West Run Planning District Board of Zoning Appeals
November 19, 2025
6:00 pm
Via Tele-Conference/Zoom Only

MEMORANDUM

Subject: Request for a Variance by CMC Malone for property legally described as Parcels 7 and 8, Tax Map 4D of the Morgan District.

Exhibit A: Site plan showing also showing the proposed decreased landscaping buffer (in light blue) and decreased parking stall width. The overall green space between the road and parking will be at least 10 feet.

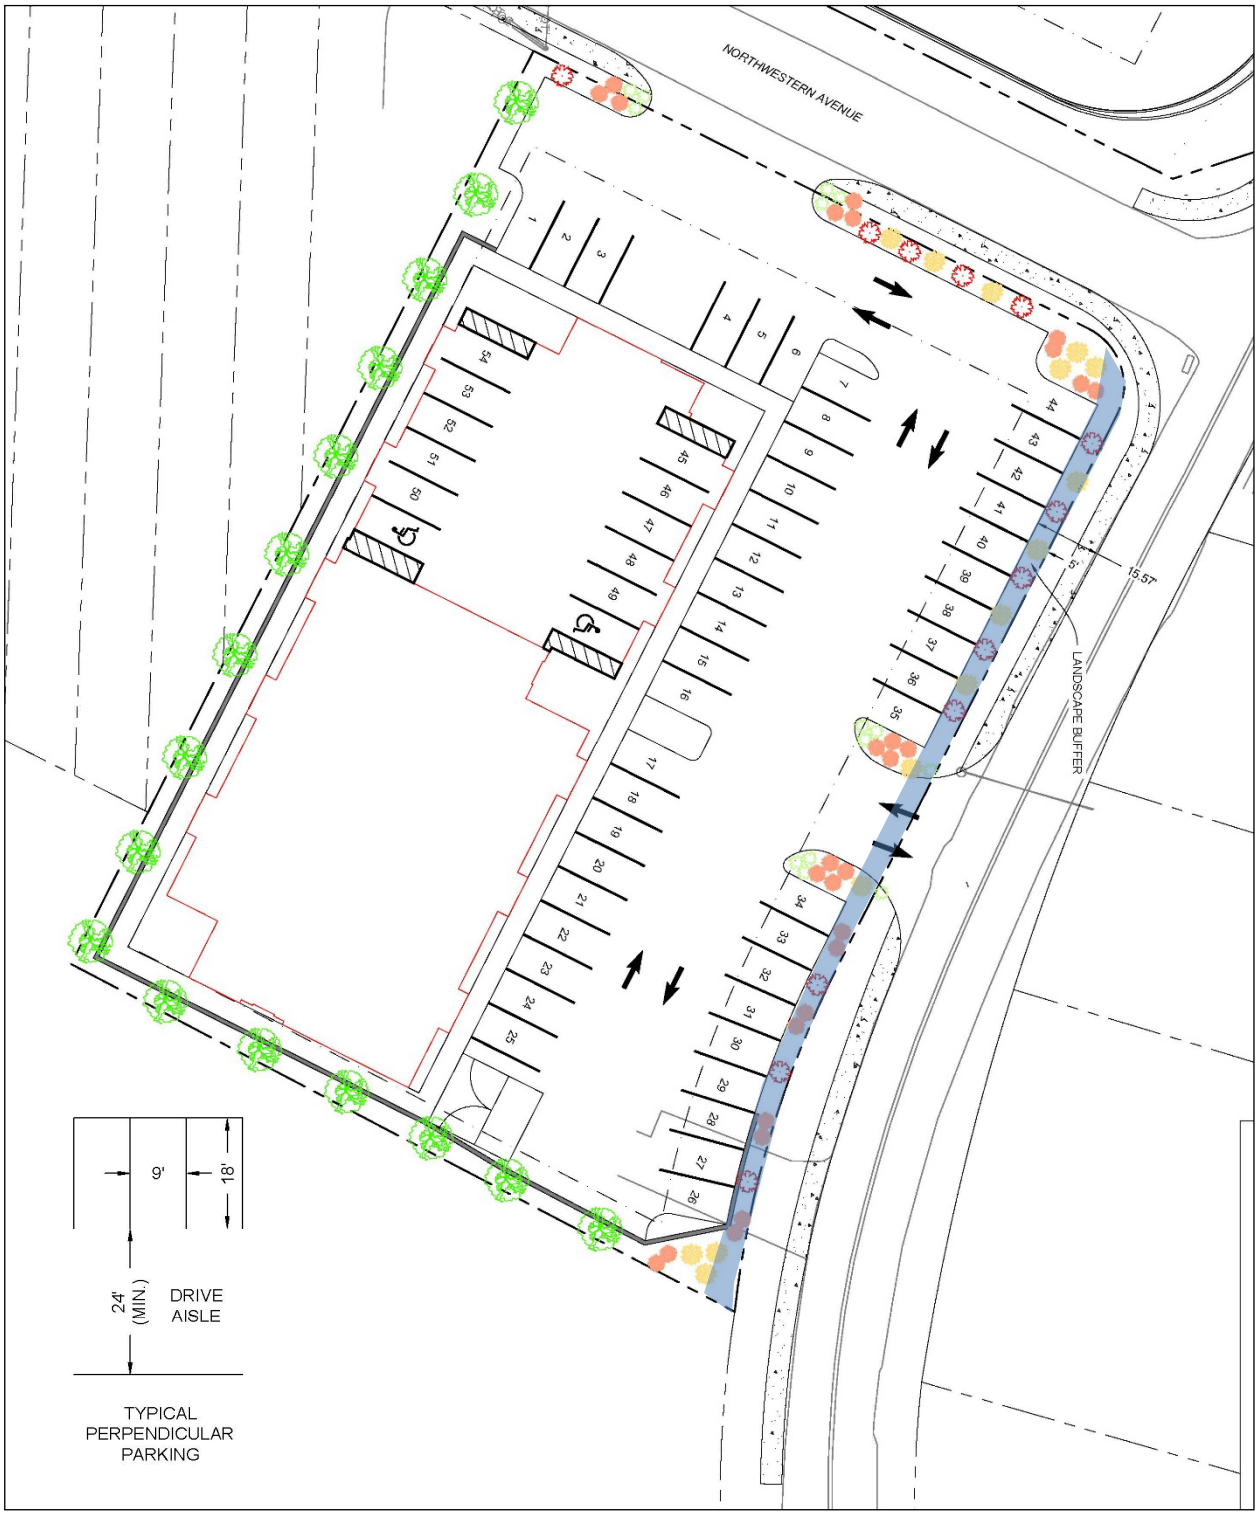
1) Reduce the parking space width to 9 feet;

Pursuant to Section 2500.07 of the West Run Planning District Zoning Ordinance, parking lot stall standards for 90-degree dimensions are: 18 feet long and 10 feet in width.

2) Reduce the landscape buffer from ten (10) feet to five (5) feet;

Pursuant to Section 2550.06 of the West Run Planning District Zoning Ordinance, new multi-family development adjacent to single family residential property (existing or zoned) shall provide a landscape buffer yard ten (10) feet wide..

1) *Based on current vehicle models, the largest width is 80 inches (not including the General Motors H1 or H2), after which other federal government requirements come into effect. This gives a clearance of 14 inches on either side of the vehicle for a 9 foot (108 inch) wide parking stall. Staff have determined that the proposed width will not decrease ease of use for the parking stalls.*

2) *The site is also adjacent to property to the north zoned R-1, however in practical use, the majority of these parcels are utilized in a commercial or multi-family capacity and have been since before zoning was enacted.*

1) *The proposed decrease in parking stall width will allow for the required parking as well as drive aisle widths. Staff has found that this approach will ensure appropriate drive aisle widths for safety and ensure the building will meet required setbacks.*

2) *While the applicant is not permitted to landscape within the right of way, it will still be grassed over and the overall green space between the road and parking will be at least 10 feet.{Note where not constrained by DOH, the applicant is providing appropriate landscaped buffering}*

1) *The decrease in parking stall width is similar size to several other adjacent locations, Northwest Court (9 by 14.5) and Charter Club (9 by 16). Northwestern Townhomes, Willow View Apts, and Silvercreek Apts are unstriped.*

2) *The proposed decrease in landscaping buffer will still include additional non-landscaped green space adjacent to the road which is not permitted to be landscaped as it is part of DOH right of way. {Note where not constrained by DOH, the applicant is providing appropriate landscaped buffering}*

Staff recommends APPROVAL to the Board of Zoning Appeals for a variance to:

A. Reduce the parking space width of the senior housing phase to 9 feet; and

B. Reduce the landscape buffer from ten (10) feet to five (5) feet;

A. The approval of this variance is based on the design of the site plan submitted with the application. Work not specified or alterations to the site plan may not be carried out without additional Planning approval.
B. Prior to the issuance of a Land Use Permit, the Applicant shall have the coinciding permit DSI 002-2025 approved by the Monongalia County Planning Commission.
